APPLICATION NO.	FILING DATE	FIRST NAMED INVENTOR	ATTORNEY DOCKET NO.	CONFIRMATION NO.
10/806,718	03/23/2004	Michael Joist	1689.007US1	2652

Office Action Summary

DETAILED ACTION

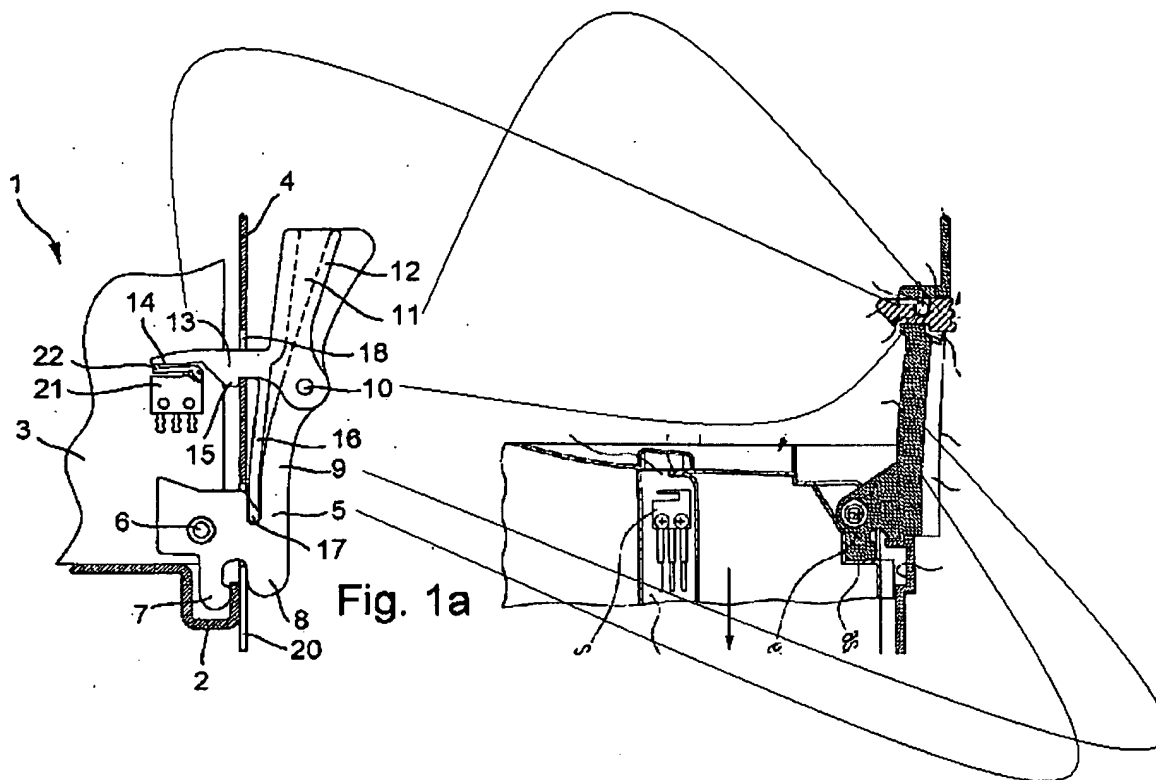
-- In reference to Claim(s) 1, Stathopoulos shows (see examiner's figure)

a circuit board;

a switch for active-passive switching of the plug-in module; and

a swivel-mounted lever/pull handle (see examiner's figure) with located in a frontal area of the plug-in module, the lever/pull handle including a gripper arm which is an integral part of the lever/pull handle; and

a control lever (see examiner's figure) which is rotatably connected to the gripper arm (see examiner's figure) of the lever/pull handle, wherein the control lever includes a stepping

pawl (see examiner's figure) to operate the switch when the plug-in module is completely inserted.
